Courtyard layout · REVISED 3 Nov 2026 · a level floor, movable furniture, the enclosure on the kitchen wall in front of the sink window · Taif / Palm House V8.2

Owner decisions 3 Nov 2026 (the V8.0 layout of 1 Nov 2026 revised: no step, no built-in benches, the enclosure moved east, the TV moved south) · clear dimensions between finished faces · the data in `3d/character.yaml` `courtyard_layout` (built in the 3D) and `studies/air_system.typ` (the grille) · every size assumed; nothing here is for construction

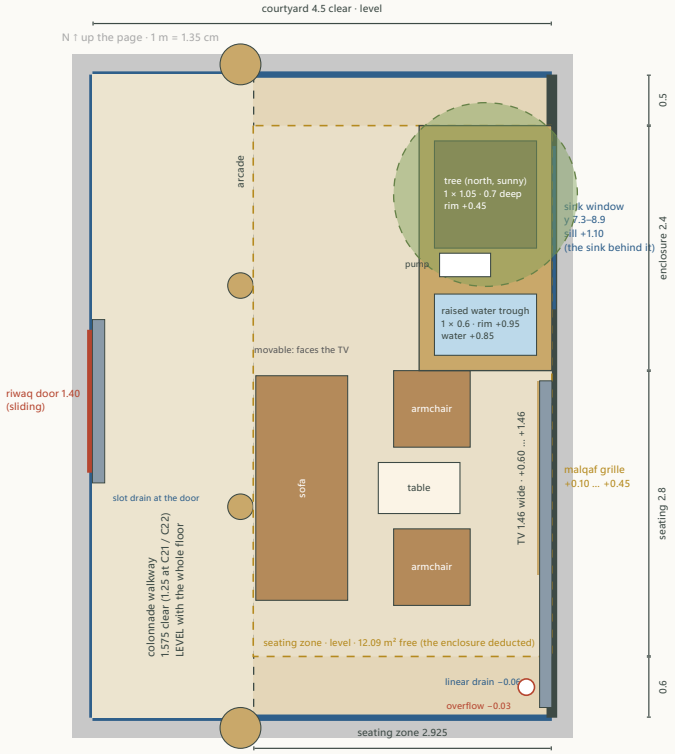
- **Courtyard:** 4.5 × 6.3 m between the finished faces (28.35 m²), **the whole floor LEVEL** (owner, 3 Nov 2026: no step anywhere; the V8.0 sunken seating is withdrawn): the colonnade walkway (1.575 m clear to the soffit edge, 1.25 at C21 / C22), the seating zone and the three cleaning strips at the glass are one surface with gentle falls (page 2). Honey-light stone, slip-resistant, no nosing, no riser light.
- **Paths kept free:** the colonnade walkway (nothing west of the soffit edge x 5.925); the riwaq door (sliding 1.40) and the living's glass (a 0.6 m strip); the women's majlis glass (a 0.5 m strip, **the north side freed**: nothing stands in front of the majlis glass any more); cleaning access along the kitchen wall between the enclosure and the chairs (0.8 m in front of the grille).

2 · Movable furniture for 4–6, facing the TV

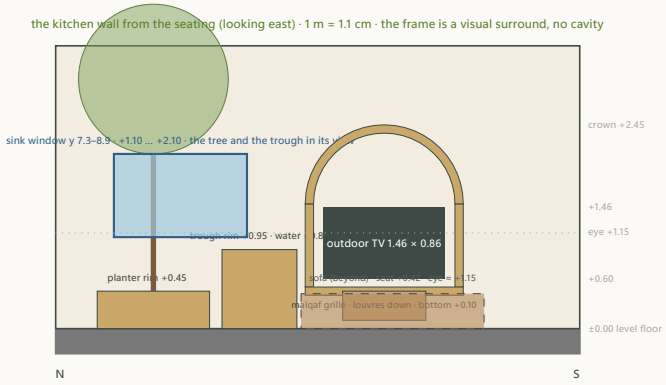
- **Modern movable pieces** (the owner chooses them): a **3-seat sofa** 2.2 × 0.9 with its back to the colonnade edge facing the TV on the east wall, **two armchairs** beside the low **table** 0.8 × 0.5 (meals, coffee): **5 seats**, 6 with two stools; everything can be moved for a big meal or cleaning. Outdoor-rated fabrics, cushions stored in the hospitality kitchen's cupboard.
- **Seating area gained:** the level zone east of the soffit edge from the north strip to the south strip is 15.21 m²; less the enclosure (3.12 m²) **12.09 m² free**, against 10.53 m² in the sunken pit: **+1.56 m² (+15 %)**; and the colonnade strip (9.92 m²) is now at the same level, so the whole 28.35 m² floor is one usable surface.
